ZONING CHANGE REVIEW SHEET

CASE: C814-2025-0111 (East Riverside PUD)

ADDRESS: 1404 East Riverside Drive

TO: PUD-NP

LAND USE PLAN

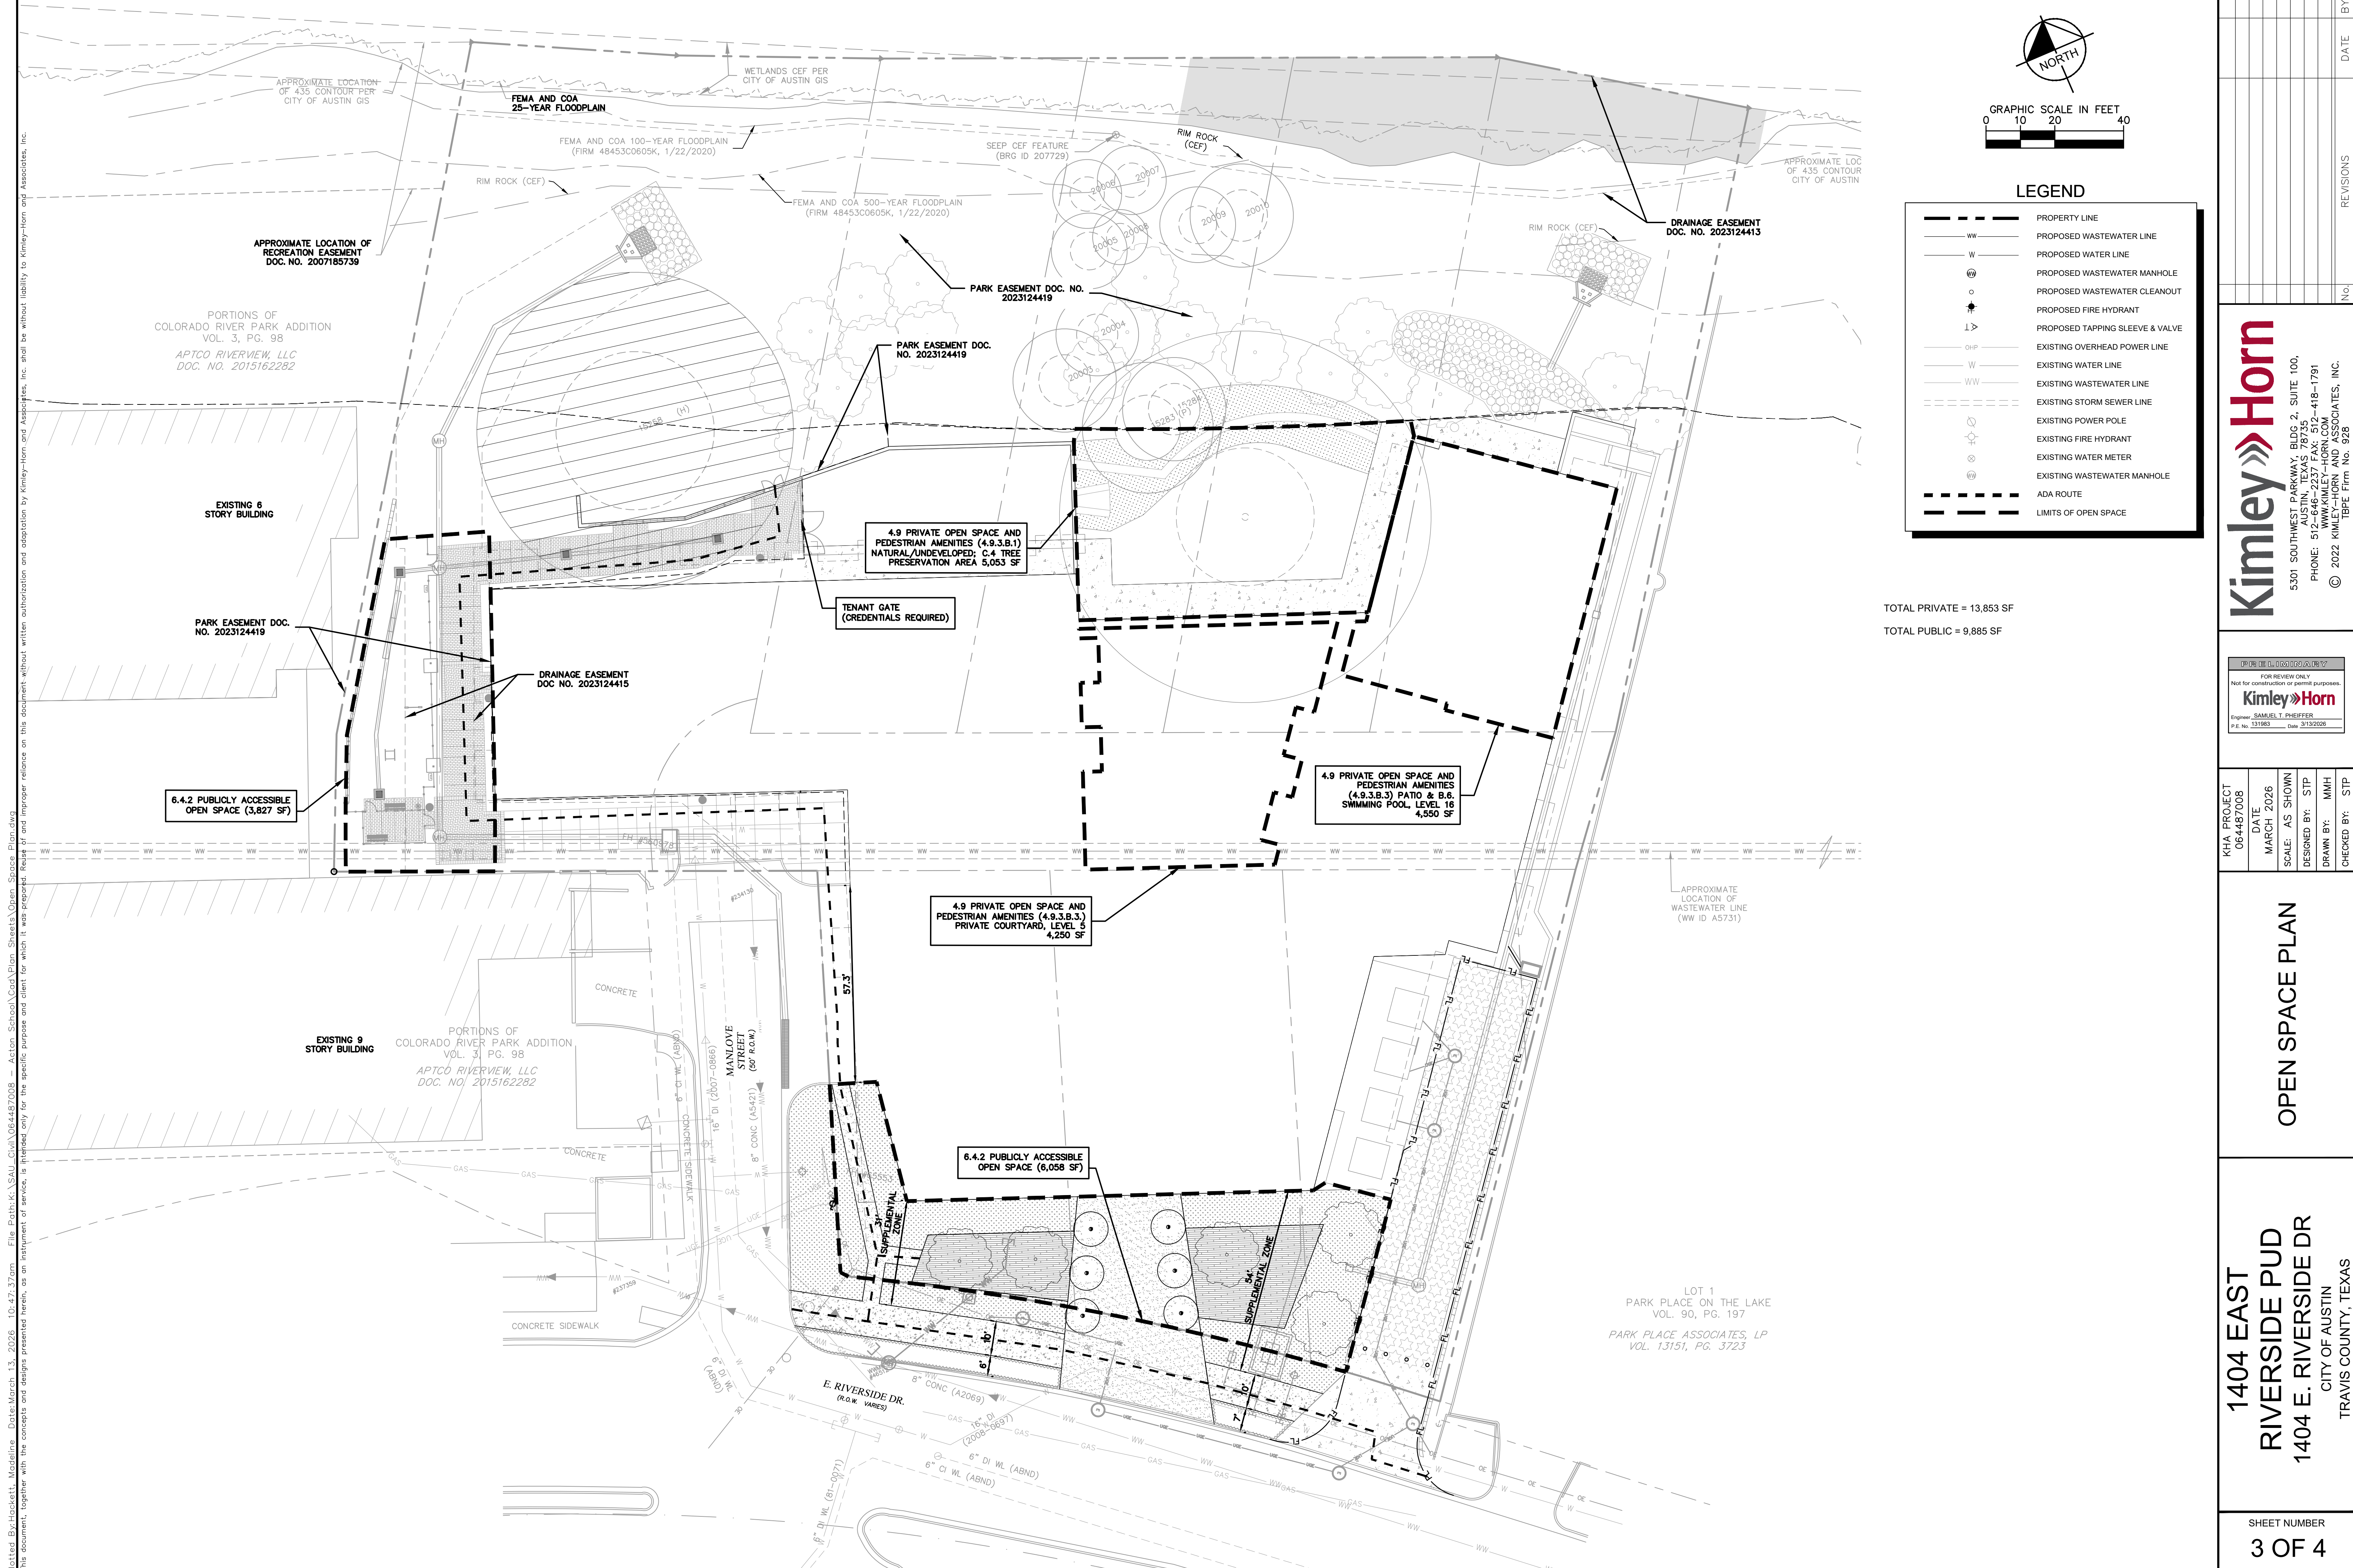
CA3 An administrative variance memo is required to request removal of Heritage trees # 15268 and 15269. Provide a variance memo addressed to the City Arborist to include the following:

DE 1. Land Use Plan Notes #8 states “a waiver to DCM 4.1.0A is approved to allow an alternative type inlet, such inlet shall be approved by the Director of Watershed Protection Department and the Department of Public Works”. Please remove. DCM Waivers are available to all projects and is not a variation from Code or Criteria. This item is also not noted in the Modification Chart.

Update 1: Comment cleared. Applicant response states that this waiver will be pursued at the time of site development. Please note that it will be reviewed at that time.

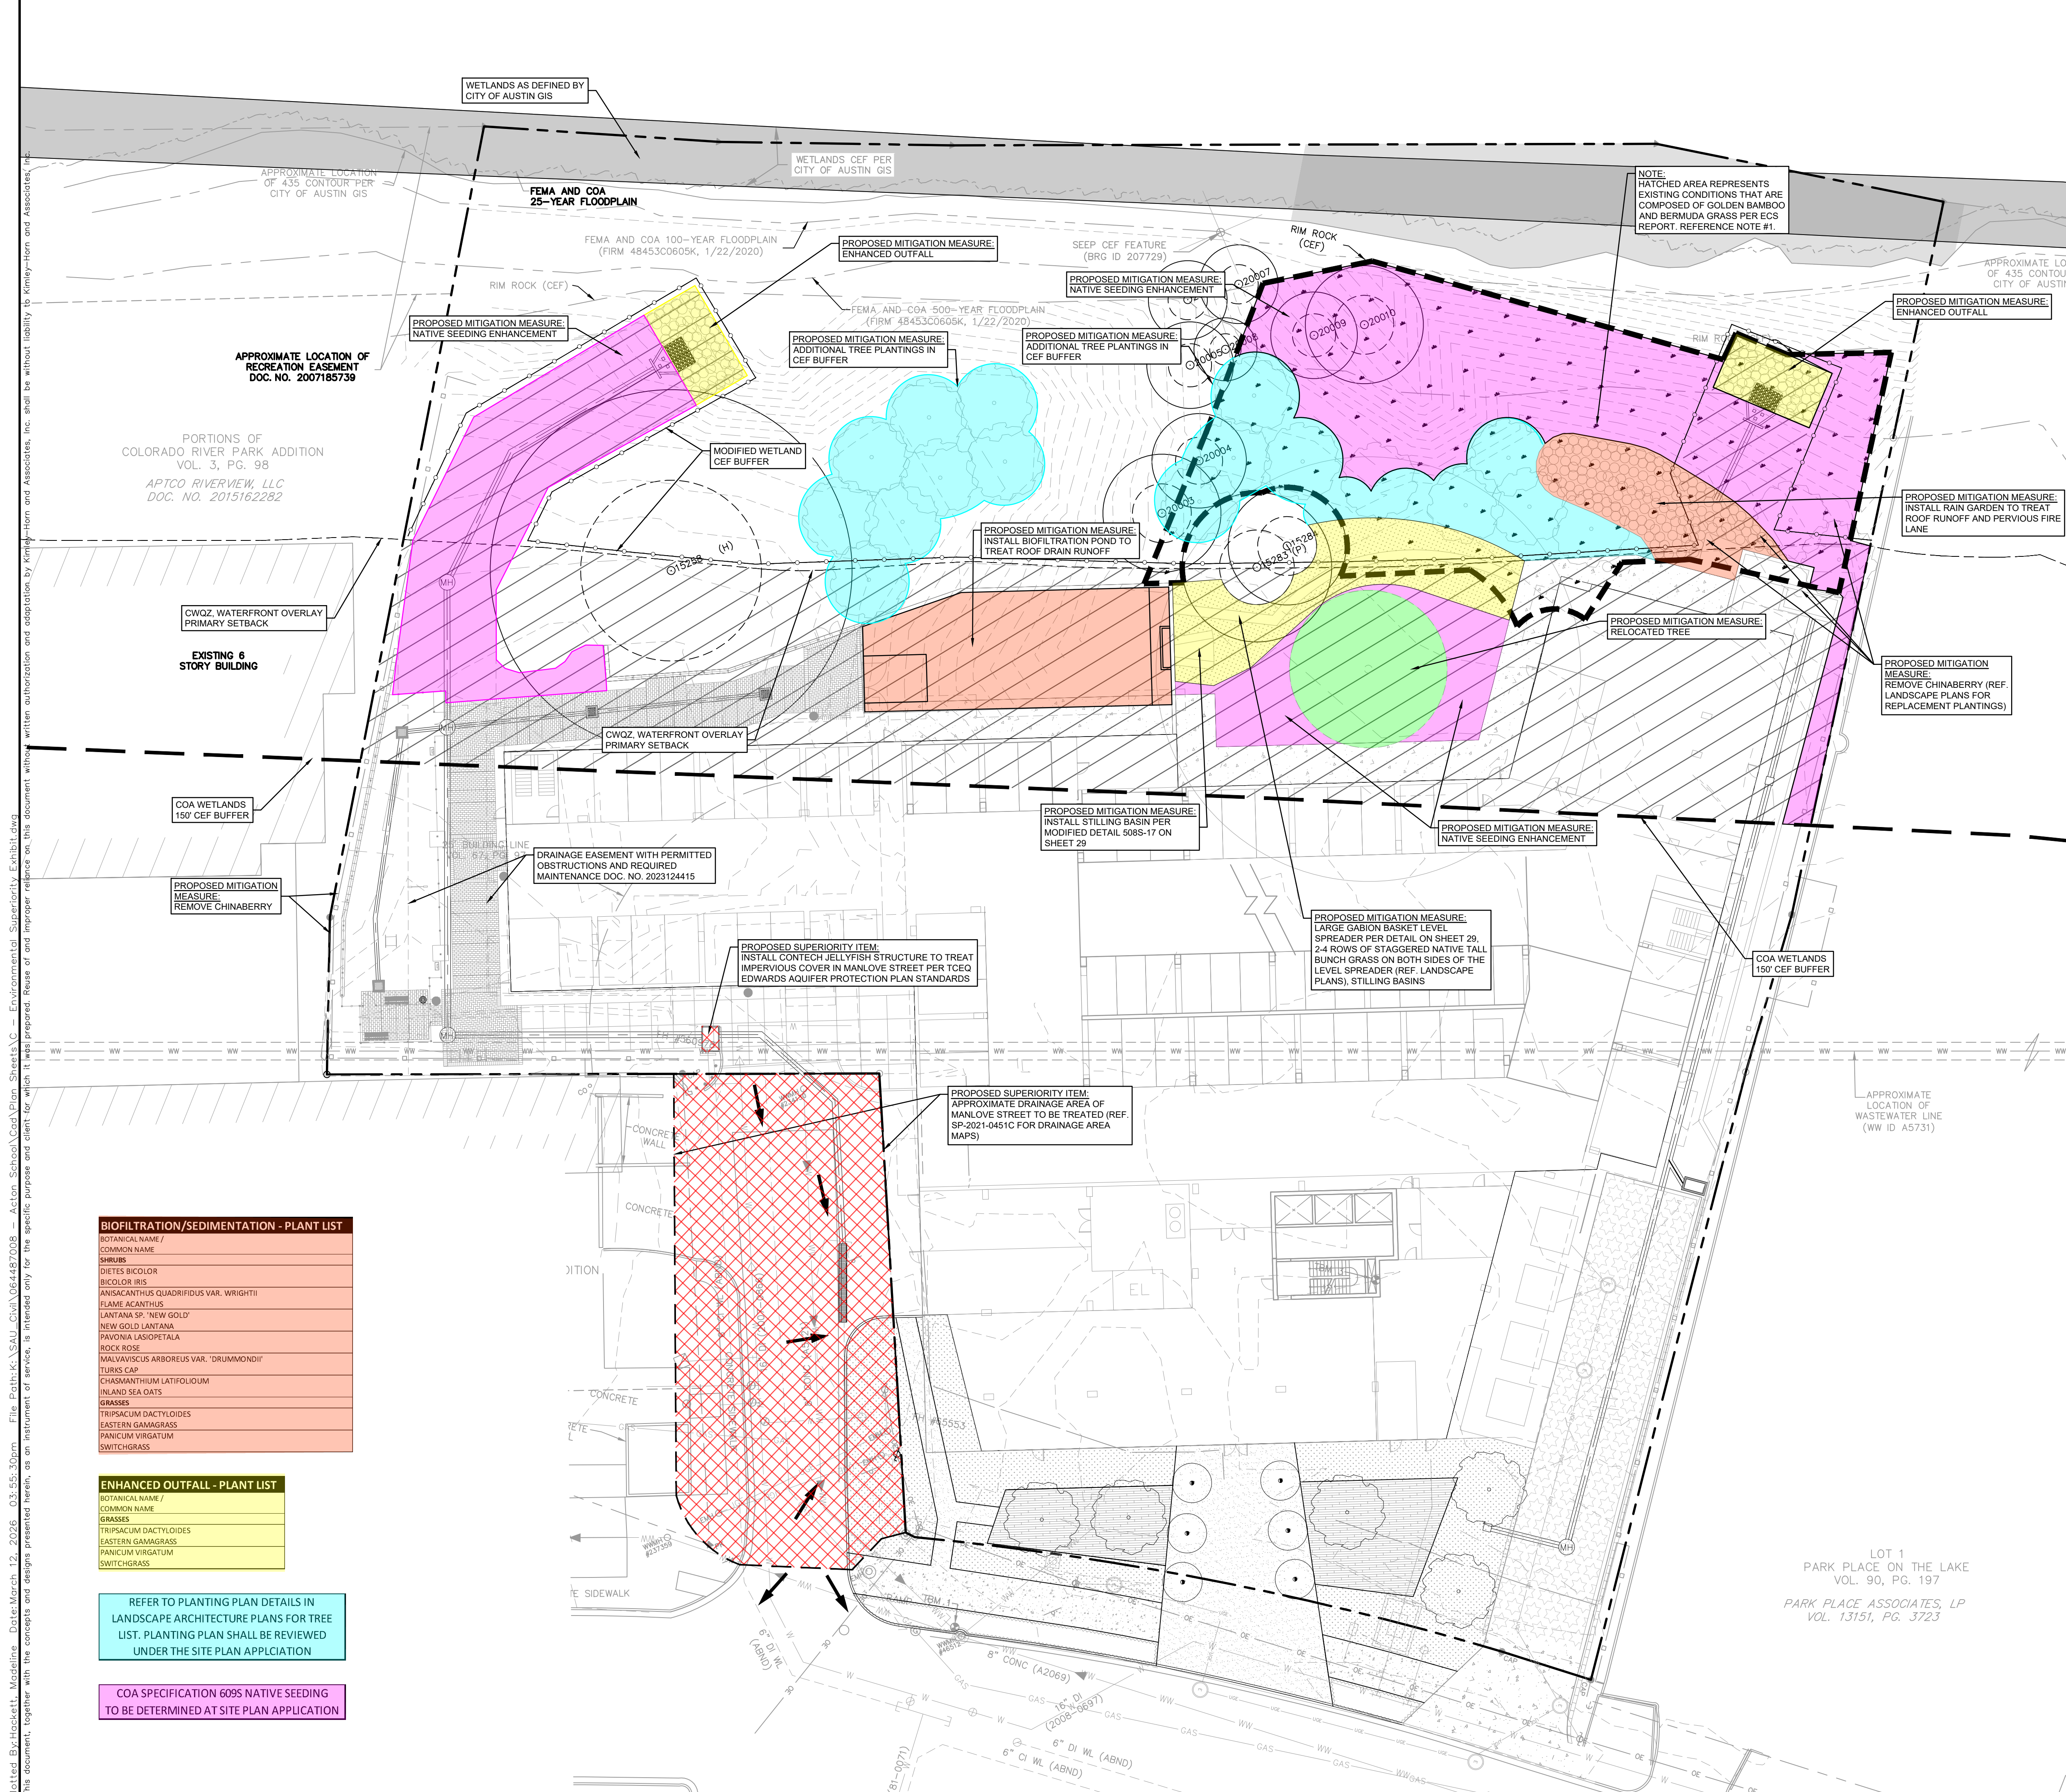
WB2. Update 0. Plant selection for GSI storm water controls must utilize plants native to the Central Texas Blackland Prairie and Edwards Plateau ecoregions and be approved by a WPD wetland biologist. For GSI quality controls, provide standards on plant diversity and species composition (e.g. minimum of 3 natives herbaceous species, all plants native to eco region, etc.)

U1. Comment partially addressed. Please replace *Buddleja marrubiifolia* (likes very dry conditions) and *Galphimia glauca* (non-native) with *Rudbeckia hirta* or *Rudbeckia maxima* and *Chasmanthium latifolium* in your Biofiltration/Sedimentation Plant List.

WB3. Update 0. Provide standards on plant diversity and species composition (e.g. minimum of 3 native herbaceous species, all plantings native to eco region, etc.) for the planting specifications within the landscape areas and designated restoration areas. Include pollinator and wildlife friendly plant species.

U1. Comment partially addressed. Please replace *Buddleja marrubiifolia* (likes very dry conditions) and *Galphimia glauca* (non-native) with *Rudbeckia hirta* or *Rudbeckia maxima* and *Chasmanthium latifolium* in your Biofiltration/Sedimentation Plant List. *Buddleja marrubiifolia* can be utilized in the landscape, but will not perform well in rain gardens, water quality ponds, at outfalls, or in areas used for treating stormwater.

WB5. Update 0. Please provide an exhibit which includes all environmental enhancements or environmental superiority efforts including restoration to the CWQZ, enhanced stabilization at the stormwater outfall(s) and any other environmental enhancements in addition to the wetland mitigation.

U1. Comment partially addressed. It is not clear to this reviewer what are the elements of environmental superiority. Please, distinguish between the minimum required mitigation and enhancements to be applied to the projects environmental superiority efforts.
